UNITED STATES PATENT AND TRADEMARK OFFICE

APPLICATION NO.	FILING DATE	FIRST NAMED INVENTOR	ATTORNEY DOCKET NO.	CONFIRMATION NO.
09/473,450	12/28/1999	SEOK HYUN YUN	5204-10	9993

Office Action Summary

FIG. 3

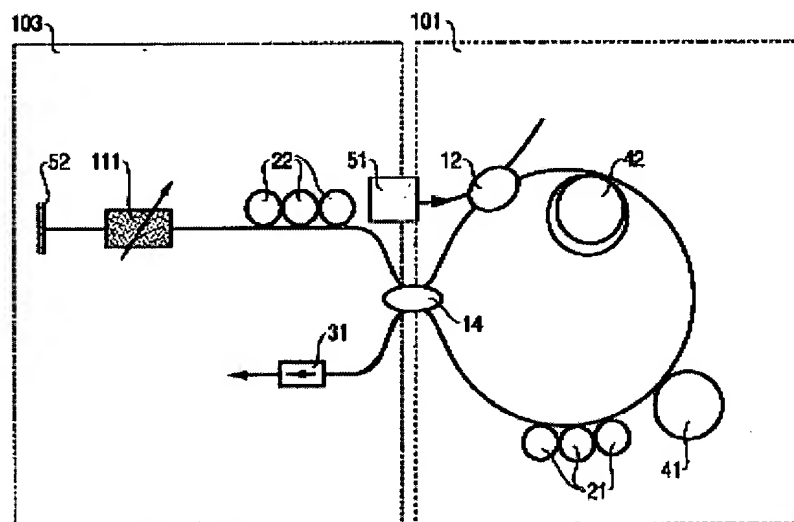
Claims 1,2,4-22 rejected under 35 U.S.C. 102(e) as being anticipated by Jeon et al (PN 5,812,567).

Figure 3 illustrates a wavelength tunable mode-locking optical fiber laser having a pump source (51), a wavelength division coupler (WDM) (12), an erbium doped gain medium (42) column 2 line 63, a dispersion shifted fiber (41) which allows for nonlinear effect column 3 line 1, polarization controllers (21) and (22), an acousto-optic tunable filter (111) for changing the wavelength, abstract, and a Faraday rotator for controlling the direction of polarization of the beam, abstract. Where the system as illustrated with an amplifying loop (101) and linear mirror (103) combined provide mode-locking of short pulses, column 4 line 40 and the abstract.
